APPENDIX H:

USACE PERMIT APPLICATION

Date Received	Entity	Comment	CBS Response	Agency Followup	Closure Email
2/21/2025	DNR	I have a question regarding the POA-2023-00433 Sitka Harbor PN on behalf of the Division of Mining, Land and Water. Is the entirety of the proposed development encompassed within the CBS municipal tideland conveyance area, or are any structures expected to extend beyond that boundary? I've attached the approximate boundary as displayed in Alaska Mapper.	We submitted an application with the boundary shown in the current mapper. In 2021 we provided an updated boundary and attached is that drawing with the corresponding public notice for the conveyance. Since then we have been waiting on survey instructions to complete the process. So as we understand it, our structures will not go outside of municipal tideland conveyance area.	Laurel Smith: Thank you for the follow up, I appreciate the additional context! I don't have further questions at this time.	March 4 from Laurel Smith

PROJECT: Sitka Seaplane Base DATE: 1/24/2025
PROJECT NUMBER: 63021.02 TIME: 9 am
ORGANIZER: Emily Creely SUBJECT: Section 408 Consultation
ATTENDEES: ORGANIZATION:
Michael Tencza USACE Sec

FIGURE 5: Marine Concept Alternatives

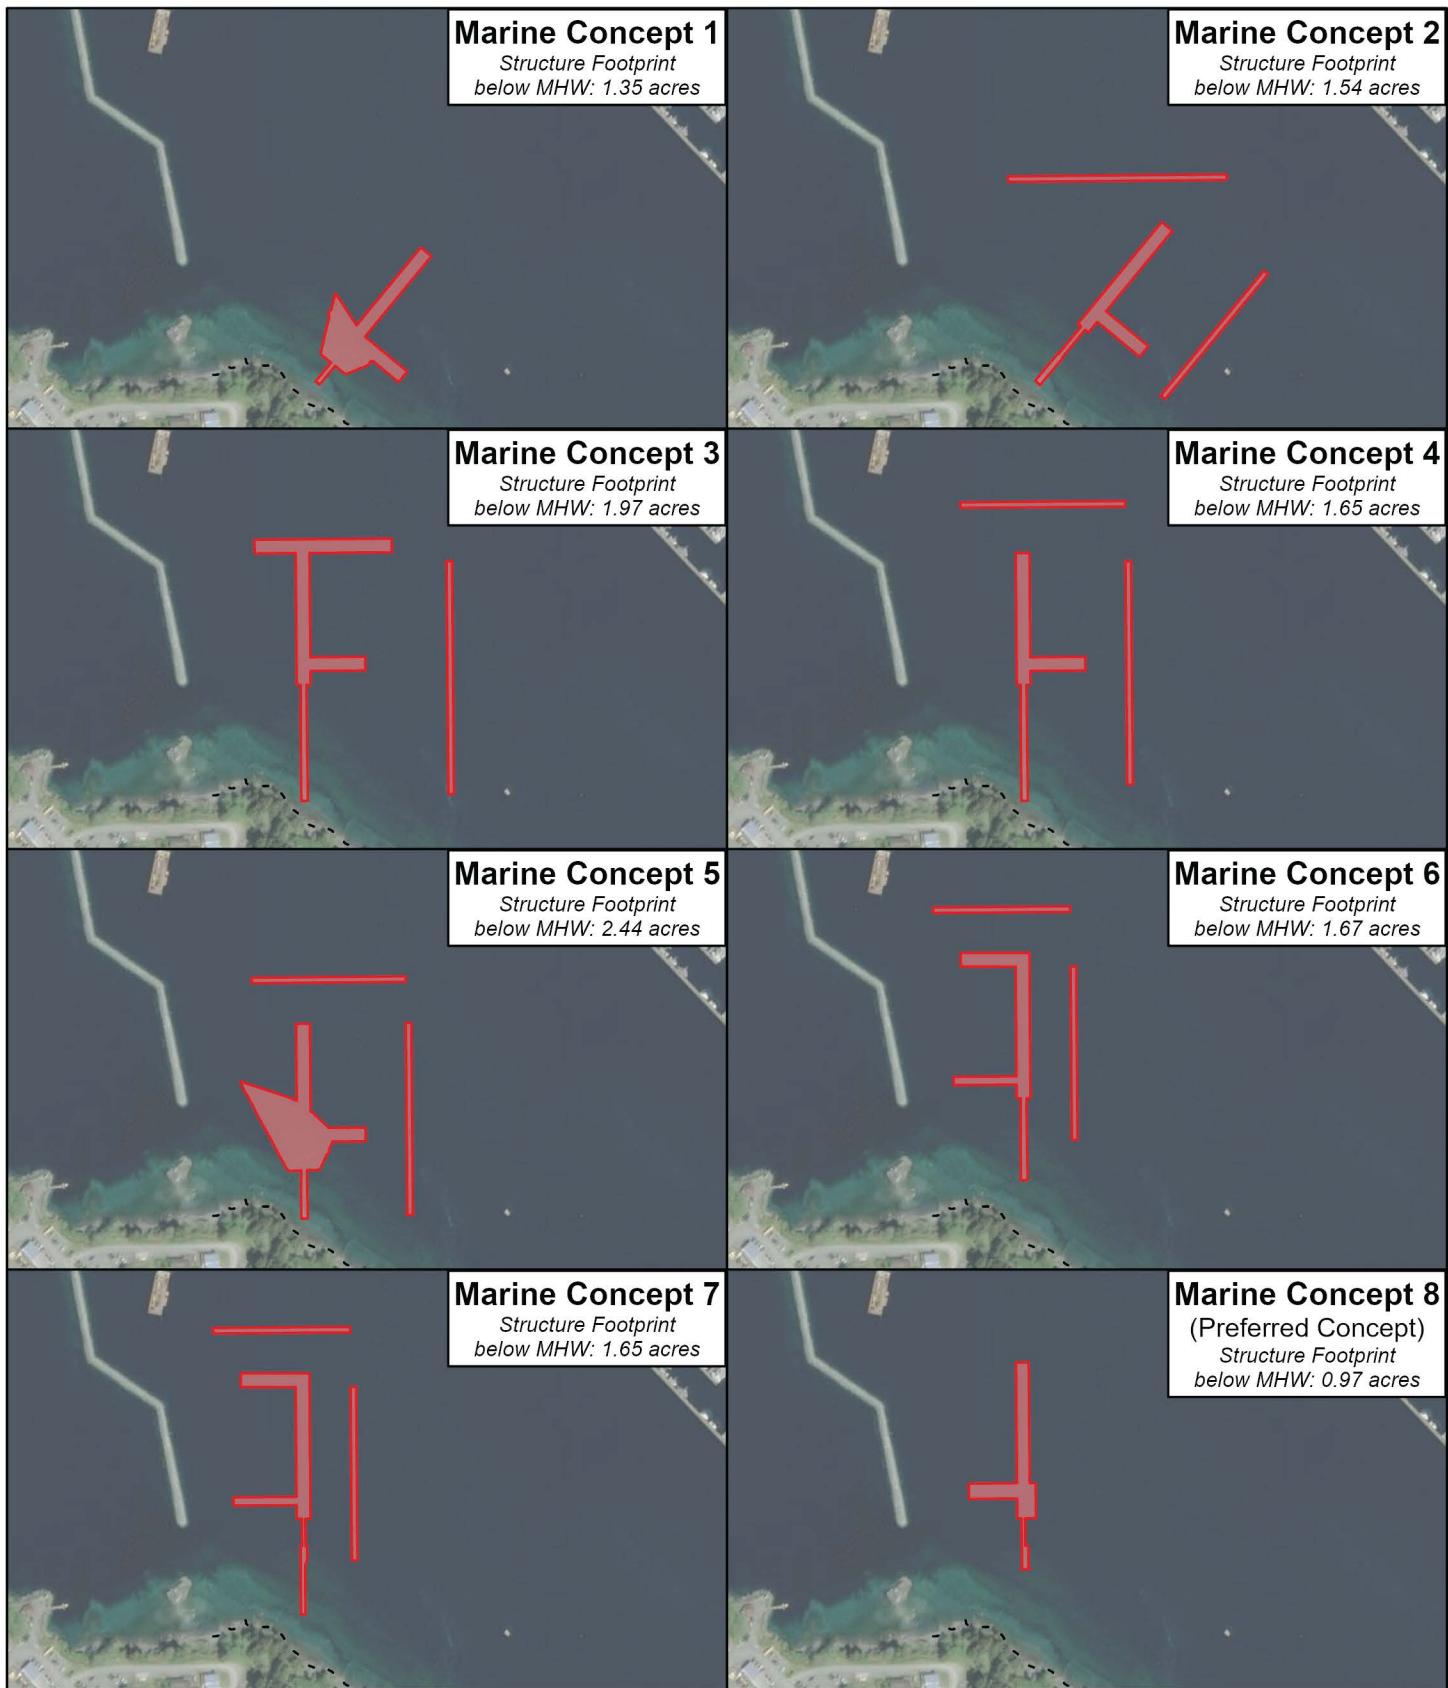
3/10/2025	USCG	Lot 15A-2 which the CG is in the process of purchasing from DEED, we should be closing later this month. It looks like the concept footprint depicted in Concepts A-F on pg. 16 of the POA-2023-00433 Sitka Harbor PN may be right up to the boundary of Lot 15A-2, but unable to verify just from the satellite images.	The project team is aware of the design as it currently stands being slightly over the lot line, however it will be changed once 65% design is initiated, along with a few other minor tweaks. So our final design will accommodate the boundaries by adjusting our cut/fill line and road placement and will not affect the Coast Guard's lotlines.	USCG: Thank you both for the quick responses. I really appreciate the discussion and coordination on this. Please let me know if there is anything else needed from my office.	March 11 to Moira Meek
